Commander C1900

Circular chart recorder/controller

New terminal block

1 Terminal block update

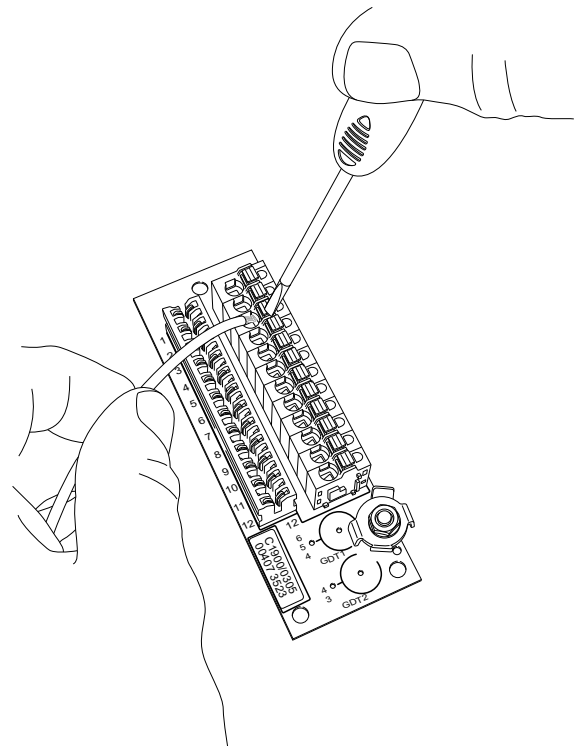
The Commander C1900 and C1300 Circular Chart Recorders now feature a new push-in type of terminal block.

Cables with solid core conductors can be inserted directly in to the terminal. To ease the insertion of multi-strand cables, we recommend the use of a cable ferrule, or to first open the terminal block by depressing the black release mechanism.

To release a cable, simply depress the black release mechanism.
